FINAL CLOSURE & RECLAMATION PLAN  
**BLAZON No.1 MINE**

Re: North American Equities Final Closure and Reclamation Plan,  
Blazon No. 1 Mine (ACT/007/021)

BLAZON NO. 1 MINE  
FINAL CLOSURE AND RECLAMATION PLAN

FIGURE 3

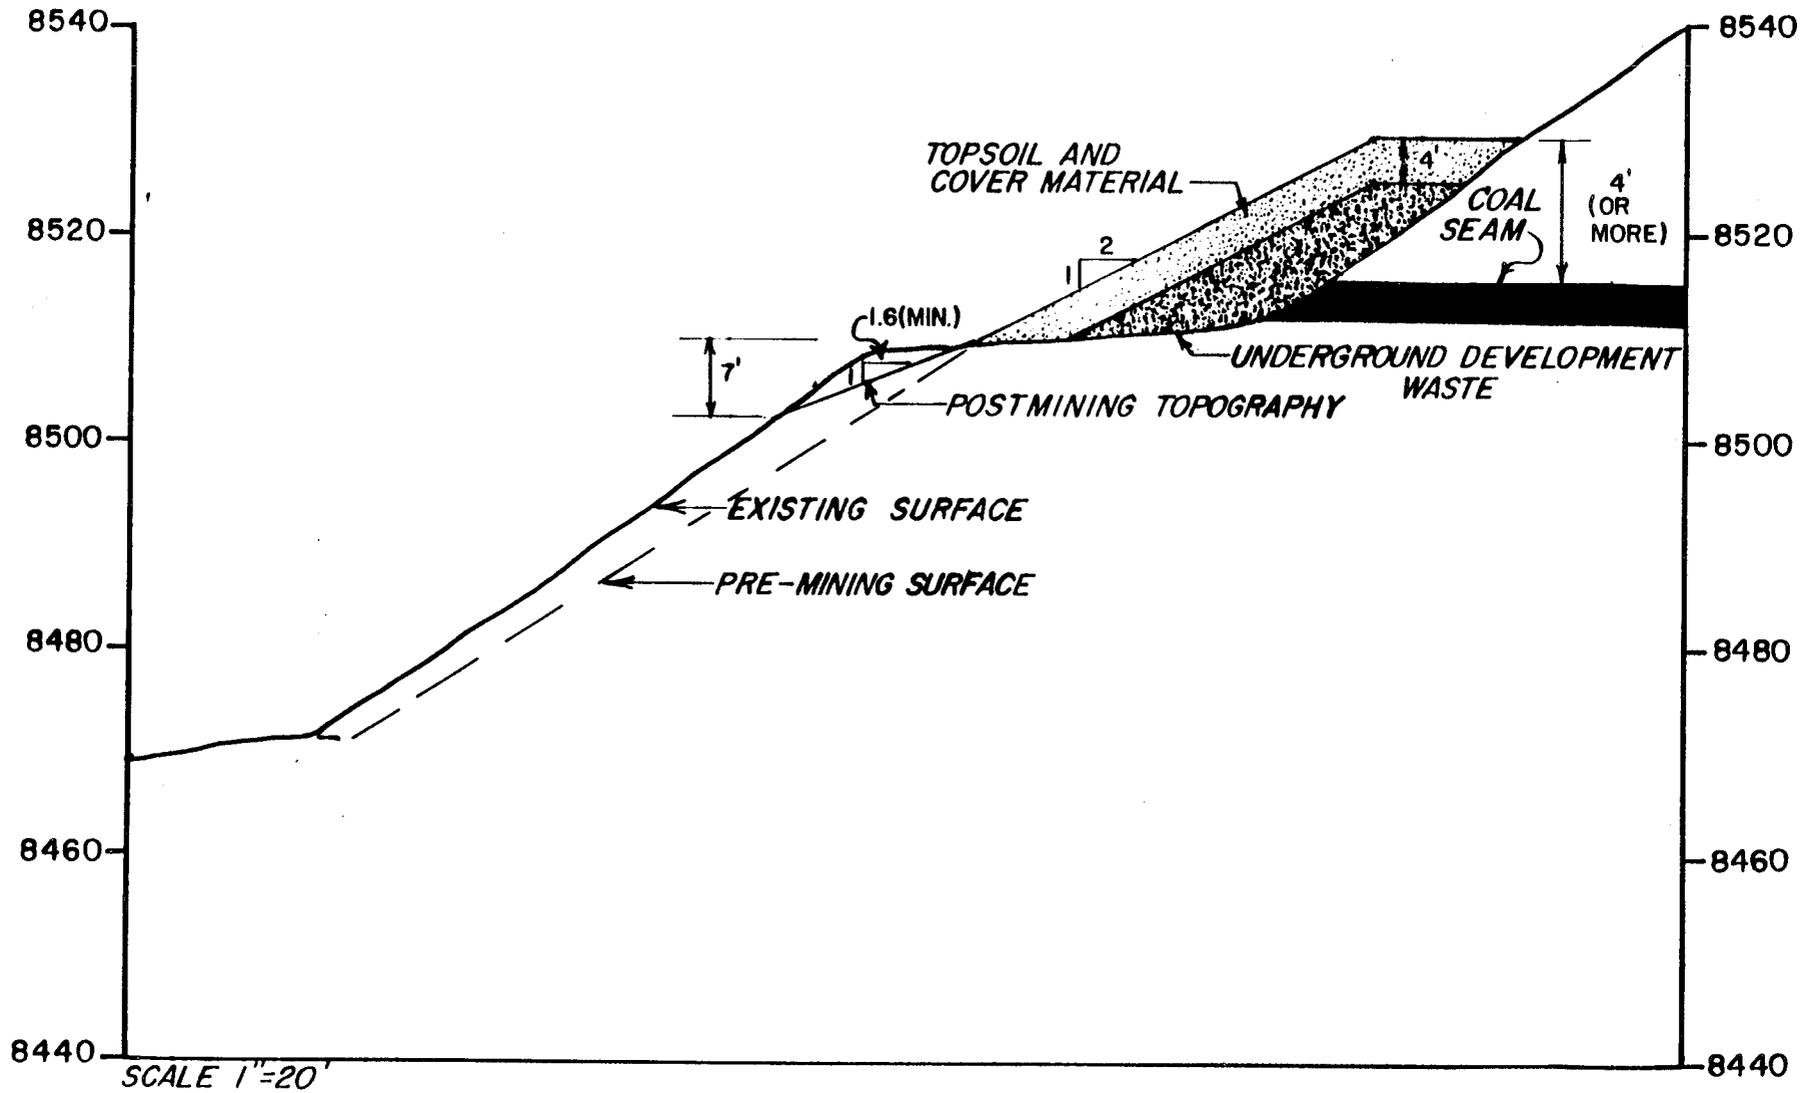
The applicant has requested a change in the depth of the fill material that will cover the underground development waste from four feet to one foot. The Division has denied the request for the change of cover depth from four feet to one foot. This decision is based on the information presented in Exhibit 15 and Oct. 5, 1985 correspondence. This material is classified as an acid- and toxic- forming material. An acid-base potential less than -5 tons of CaCO<sub>3</sub>/ 1000 tons of material is determined to be an acid- and toxic- forming material. The submitted underground development waste analytical data has an acid-base potential between -6 and -8.7 tons of CaCO<sub>3</sub>/ 1000 tons of material. This acid- and toxic- potential may be alleviated with the application of 9 tons of a fine mesh limestone to the underground development waste. The CaCO<sub>3</sub> must be thoroughly mixed with the underground development waste material prior to burial.

1. Utilize underground development waste to cover the portals with a minimum of four (4) feet above the coal seam as shown on Figure 3, Typical Section Reclaimed Mine Bench. Place in lifts of one (1) to
